September 2, 2015
Job No. 15-0018

**Re: Geological Review of the Stormwater Site Plan (SSP)
Proposed Rosario Resort Expansion
1400 Rosario Road & 3231 Olga Road
Eastsound, WA 98245
TPN 160621001000 & 173043001000**

FIGURE 6.6 STORMWATER PLAN - ROSARIO UPPER HILLTOP AREA

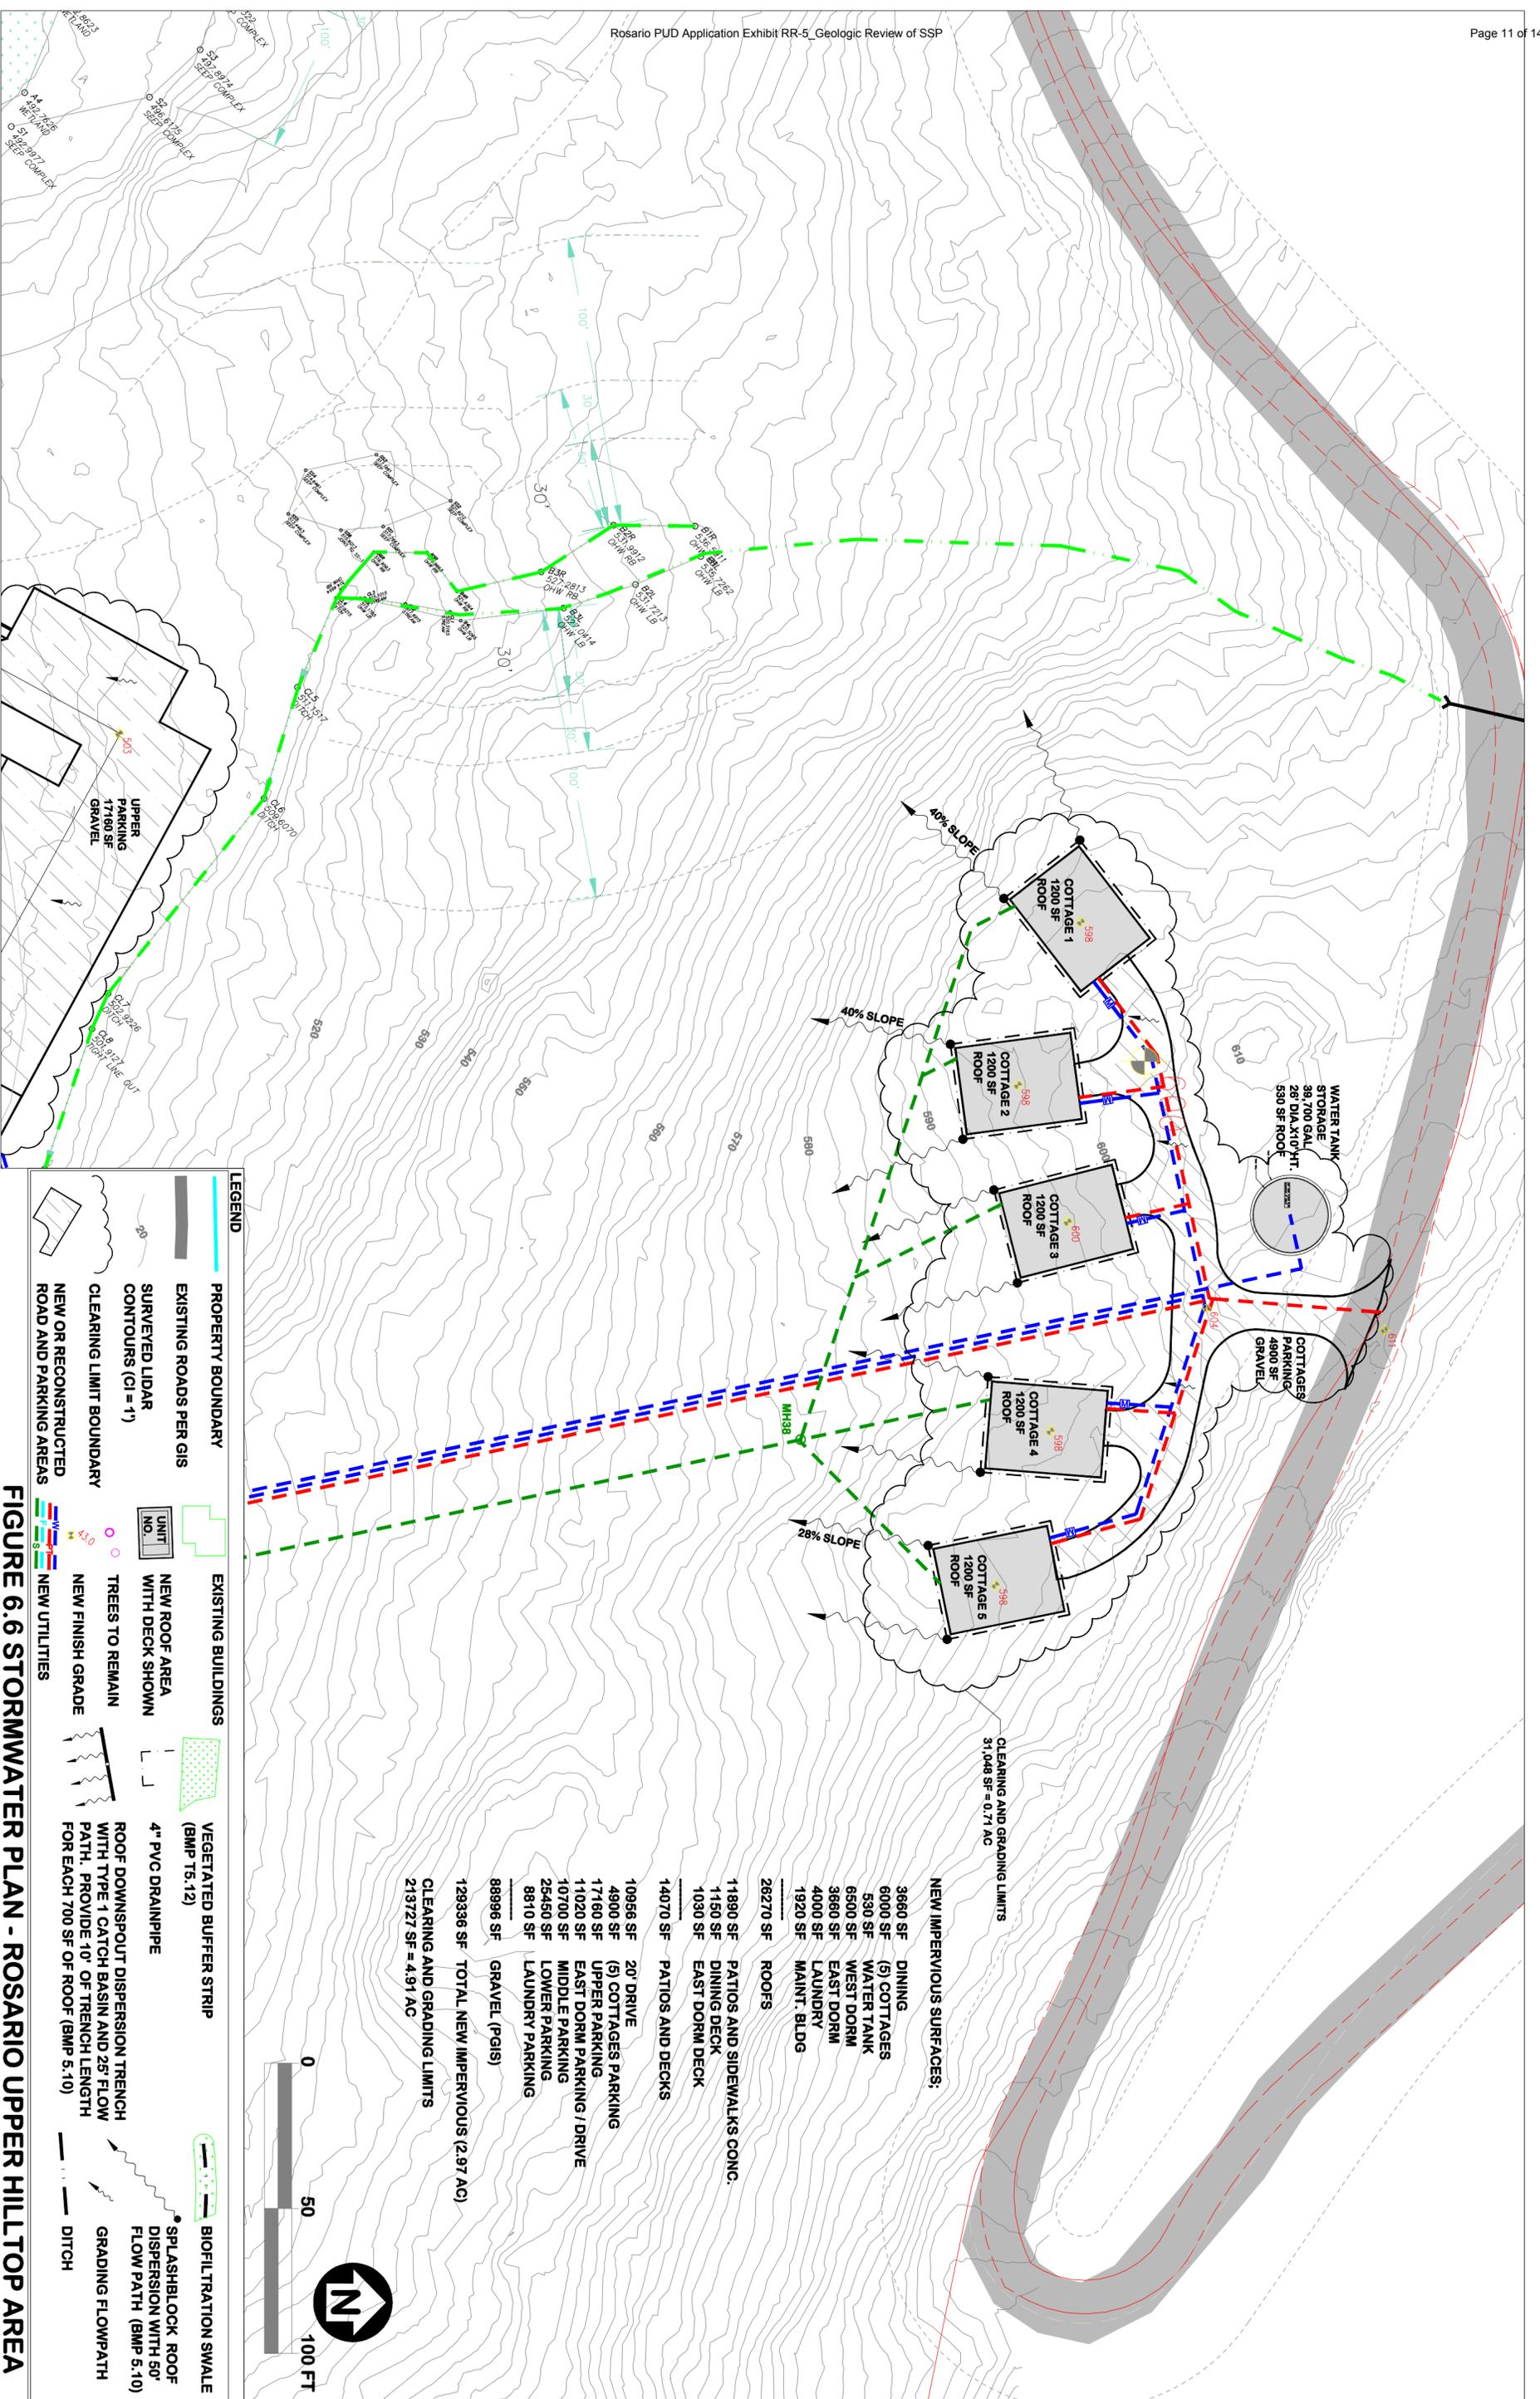
- **Existing Dorm Roof:**

The proposed dispersion trench location may need to field fit and/or adjusted in elevation due to the presence of previously placed fill in this location.
